**ZONING AMENDMENT,  
& SUBDIVISION STAFF REPORT****Date: May 20, 2010****APPLICANT NAME**

Live Oak Grove Subdivision

**CONTEMPLATED USE**Subdivision approval to create 2 legal lots of record, and  
Zoning approval to rezone the site from R-1, Single-Family  
Residential and I-1, Light Industry, to I-1, Light Industry,  
to allow two (2) radio towers and a 300 square foot  
operation building and to eliminate split zoning.**It should be noted, however, that any use permitted in  
the proposed district would be allowed at this location if  
the zoning is changed. Furthermore, the Planning  
Commission may consider zoning classifications other  
than that sought by the applicant for this property.****REASON FOR  
REZONING**Applicant is requesting rezoning of the site to allow two (2)  
radio towers and a 300 square foot operation building and to eliminate split zoning.**TIME SCHEDULE  
FOR DEVELOPMENT**

SITE PLAN

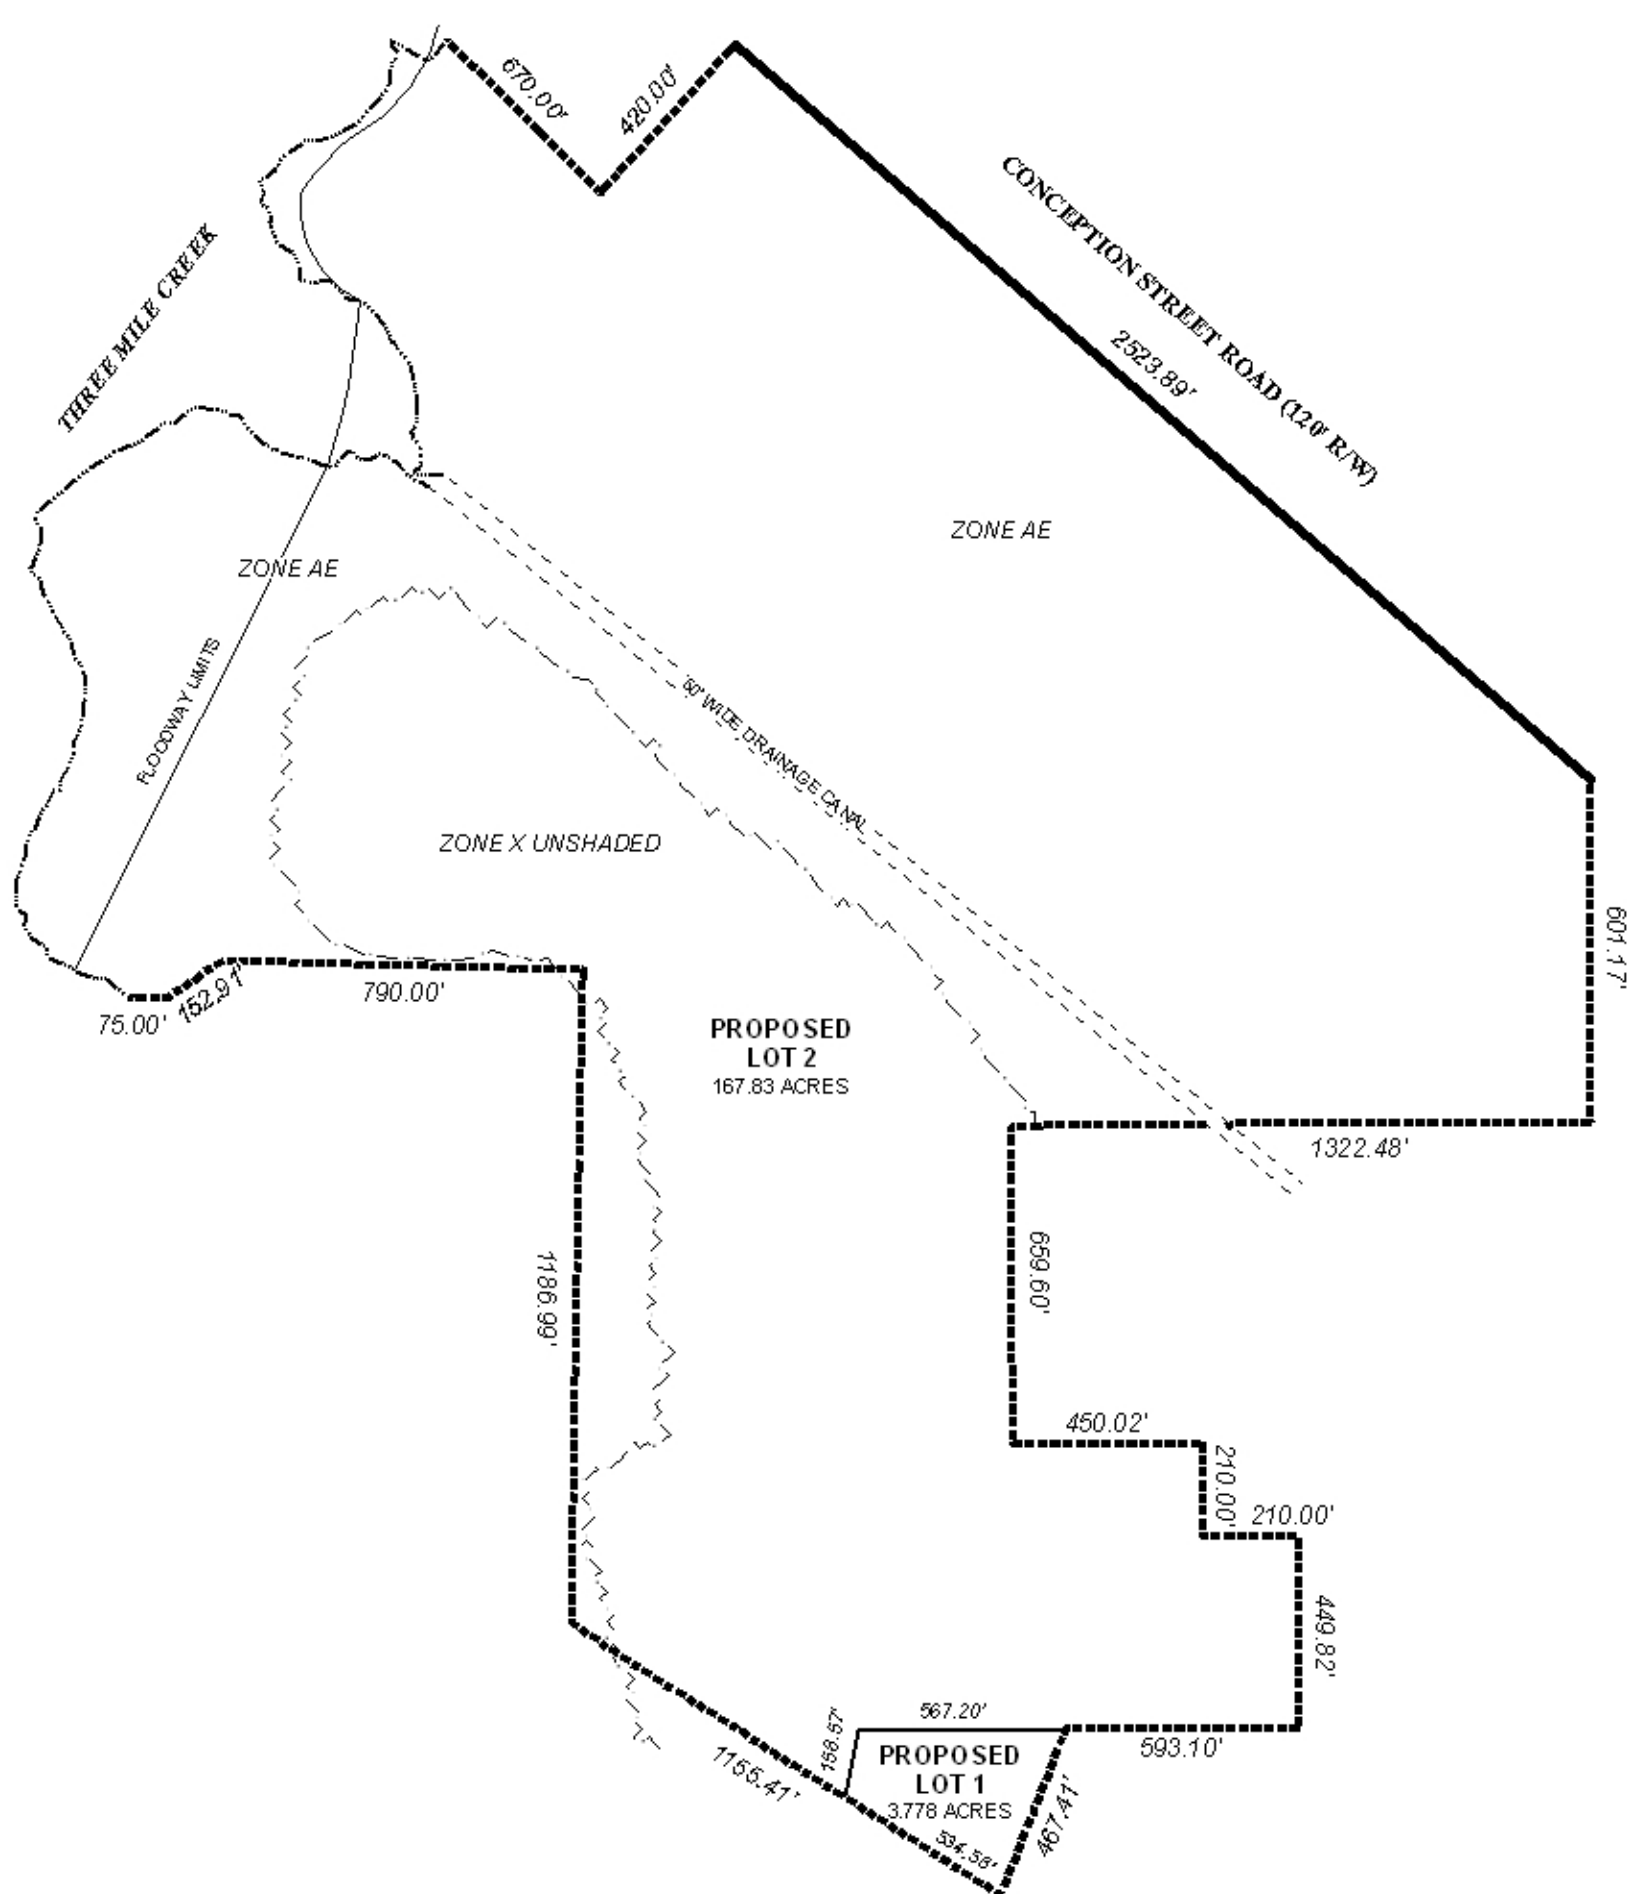
Major Street Component of the Comprehensive Master Plan, providing 120-feet of right-of-way on its northern boundary. As illustrated on the preliminary plat it appears that a 50-foot± wide drainage canal bisects the entire site, creating a natural buffer. It would not be favorable or cost effective to construct a bridge to access the entire property from either street. It should also be noted that the unimproved right-of-way of Peach Street traverses wetlands as illustrated on the preliminary plat and has an existing drainage structure within the right-of-way; therefore, leaving the applicant the only option of purchasing enough land from the City of Mobile for access from the unimproved Live Oak Street. Sufficient right-of-way is provided on Live Oak Street ensuring that the development has a right-of-way width of 50 feet; however, the developer would simply continue the street to city standards to access the development. It should be noted that approximately 21,000 square feet is proposed to be purchased from the city of Mobile for this access; this small section is the only portion of the entire site the applicant is requesting rezoning from R-1, Single-Family Residential to I-1, Light Industry.

No protection buffers are depicted on the site plan; however, Section 64-4.D. would require the minimum provision of a 10-foot wide buffer. As industrial uses can be prone to high levels of noise and dust; however, the location of radio towers should not require the applicant to provide a wider planted buffer (10-feet), the protection of the major portion of any existing vegetation on the site, and the provision of a wooden privacy fence where the site abuts residentially zoned properties to the South.

The site plan does not depict any site improvements other than a proposed two (2) radio tower, a small (300 square foot) operation building and a 24-foot wide stone drive with two parking spaces. Development of the site must comply with the requirements of the Zoning Ordinance, thus frontage trees will be required, dumpsters must be depicted if proposed, and a sidewalk must be built along all street frontages.

No storm water detention facilities are depicted on the site plan, however, compliance with the storm water and flood control ordinances may be required.

The 25-foot minimum building setback line from all street frontages, required in Section V.D.9. of the Subdivision Regulations, is not shown for the subdivision, but would be required on the final plat, if approved.

- 1) construction of the extension of Live Oak Street to the development to city standards;
- 2) placement of a note on the Final Plat stating that the site is limited to one (1) curb-cut onto the development, with the size, design and location of all curb-cuts to be approved by Traffic Engineering and in conformance with AASHTO standards;

- 3) provision of a 10-foot planted buffer and privacy fence along the South property line, where the site abuts the Bottoms community;
- 4) placement of a note on the plat stating that approval of all applicable Federal, state and local agencies is required for endangered, threatened or otherwise protected species, if any, prior to the issuance of any permits or land disturbance activities;

- 6) depiction and labeling of the 25-foot minimum building setback line, reflecting any required dedication;
- 7) compliance with Engineering comments (*Show Minimum Finished Floor Elevation on Plat. There is to be no fill placed within the limits of the flood plain without providing compensation. Must comply with all storm water and flood control ordinances. Any work performed in the right of way will require a right of way permit*); and

- 8) labeling of the lots with its size in square feet and acres.
